These amendments revise the TSs to correct the values for the Axial Power Shaping Rod (APSR) Position Limits after 385 EFPD for the Unit 3 Cycle 7 of operation.

SAFETY EVALUATION BY THE OFFICE OF NUCLEAR REACTOR REGULATION
SUPPORTING AMENDMENT NO. 126 TO FACILITY OPERATING LICENSE NO. DPR-38

OCONEE NUCLEAR STATION, UNITS NOS. 1, 2 AND 3

Figure 3.5.2-4C3

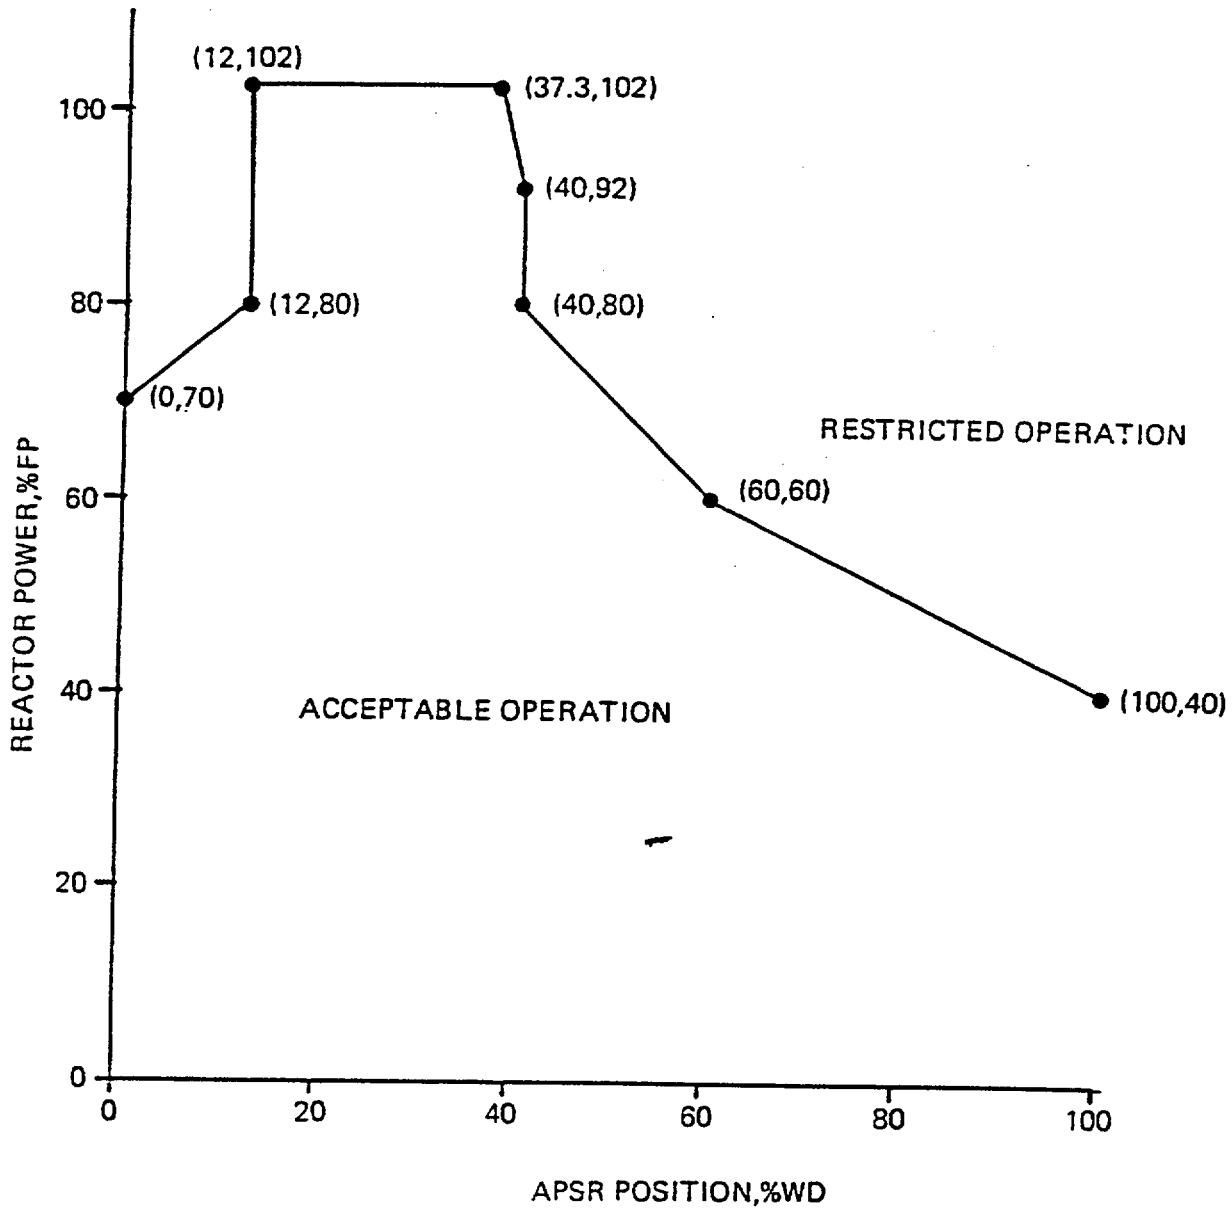
In a submittal dated September 14, 1983, DPC disclosed that while calculating the Oconee Unit 2 Cycle 7 TSs, they became aware that a correction should be made to the APSR position limits of Unit 3 after 385 Effective Full Power Days (EFPD). Review and evaluation of the Oconee Unit 3 TS change was requested along with the Oconee Unit 2 Cycle 7 reload review and evaluation. The Unit 2 Cycle 7 reload TSs, including the APSR position limits for Unit 2 Cycle 7 and the corrected APSR position limits for Unit 3 Cycle 7, were subsequently reviewed and found acceptable. By letter dated November 23, 1983, the Commission issued Amendments Nos. 124, 124 and 121 revising the TSs to allow full power operation of Oconee Unit 2 during fuel Cycle 7, but for administrative reasons, deferred the issuance of the Unit 3 Cycle 7 corrected APSR position limits to a later date as a separate licensing action. This evaluation addresses the deferred Unit 3 Cycle 7 corrected APSR position limits.

The difference in the APSR position limit was caused by poor convergence of the calculated power distribution for Oconee Unit 3 Cycle 7. The discrepancy was discovered at the time of the preparation of the Oconee Unit 2 Cycle 7 reload but before Oconee Unit 3 reached 385 EFPD. Therefore, no period of potentially unsafe operation occurred. The appropriate report was filed.

Inasmuch as the calculation was carried out with an approved method and the recommended number of iterations was used, we find the requested TS change acceptable for Oconee Unit 3.
